1247 Westbrook Street

APPLICATION FOR PERMIT

To erect screen house, 8 x 8 to set on wooden foundation as per plans. 1 sheet of plans. Stamp of Special Conditions

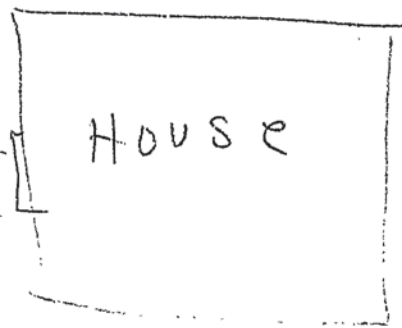
5-9-80 Not started yet -
 5-15-80 Not started yet -
 7-3-80 bldg is up - not a fancy
 'give please bldg' - my only concern
 is with the flat roof & snow loads
 I left a tag to RAL' one (no one
 home) - plans submitted to city permit
 not sufficient - lot lines appear
 OK - ~~no~~ - owner called back &
 explained that she was going to attach
 a slanted corrugated
 sheet roof to take
 care of snow - as she
 explained it it should
 be OK -

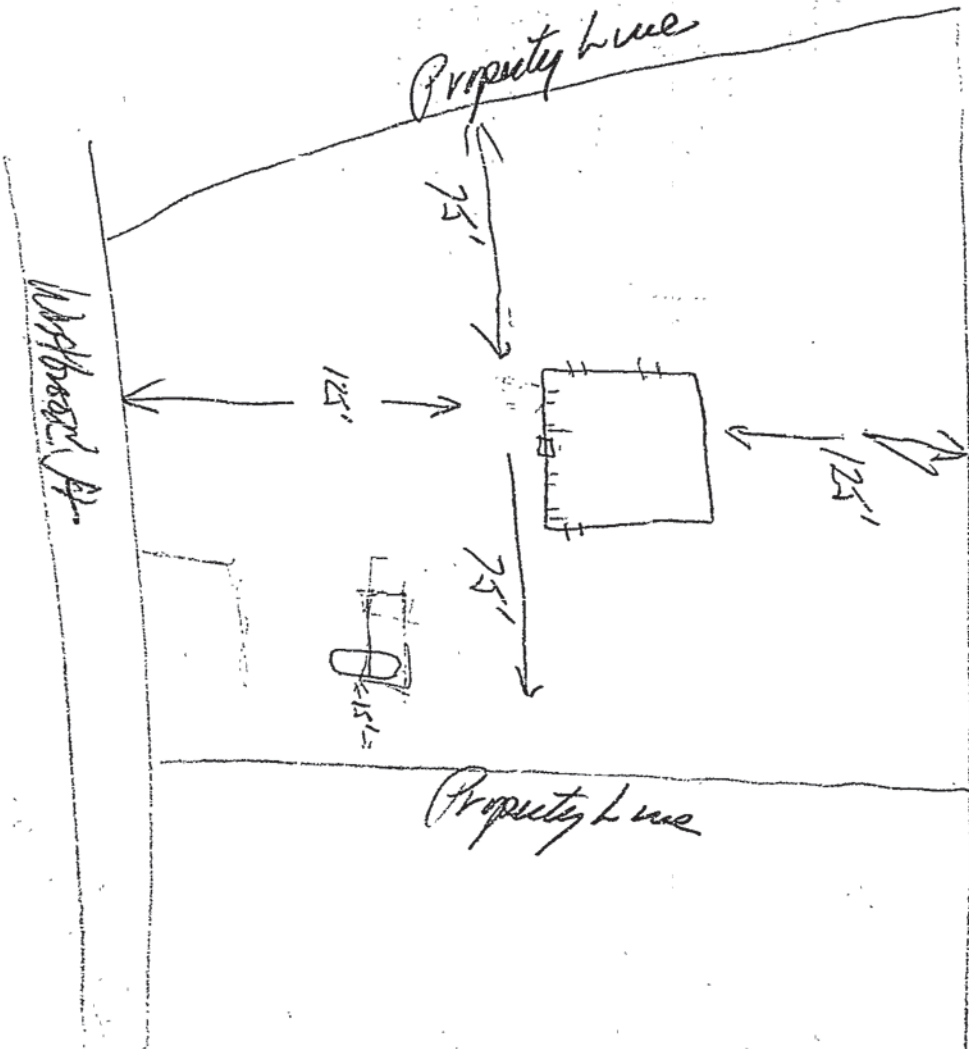
Permit for installation at the above named location of a 500 gallon above ground propane gas tank in location shown on plan filed with application for permit has been approved by the Fire Department subject to the condition that the tank shall be supported on a suitable concrete base or concrete blocks and that all valves, regulators, gauges, and other container fittings are suitably protected against tampering and physical damage. Permit is issued on the basis of compliance with these conditions.

The permit to install one 500 gallon L.P. tank at 1247 Westbrook Street is approved by this office providing that the tank is erected on a suitable cement base or concrete blocks and that all valves, regulators, gauges, and other container fittings are suitably protected against tampering and physical damage.
